**RE: Residential Subdivision Lot 1, Bayside Way, Brunswick Heads (MP05\_0091)**

I refer to the department's letter addressed to Jim Glazebrook of Jim Glazebrook & Associates Pty Ltd dated the 30<sup>th</sup> of January 2012, outlining issues raised by the department and submissions. This letter addresses a number of issues raised in Appendix 1, Item 3: *Traffic and Roads*.

**Figure 1: Existing Intersection Arrangement for Old Pacific Highway and Bayside Way**

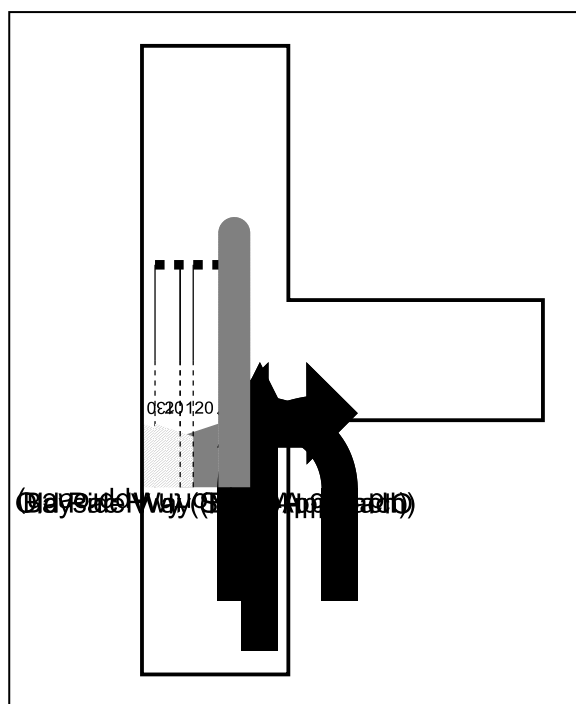
**Item 3 d)** *The proponent should consult with Council's traffic engineer regarding the intersection analysis at the Gulgán Road (Old Pacific Highway) and the suitability of the proposed intersection upgrades. Council's comments regarding the appropriateness of the proposed intersection upgrades should be included in any response to submissions.*

TTM has met with Byron Bay Council's traffic engineer, Simon Bennett, on the 17th of April 2012. During this meeting TTM discussed the Old Pacific Highway / Bayside Way intersection, providing Mr. Bennett with TTM's 2010 SIDRA Intersection outputs, revealing that the intersection has no performance issues up to 2022 with the inclusion of the development traffic. The extract from the TTM Traffic Impact Assessment report Nov 2010, as indicated below, was shown to Simon Bennett.

Mr. Bennett agreed with TTM's conclusion that there were no future capacity issues at the intersection and hence no upgrades to the intersection would be required due to the development.
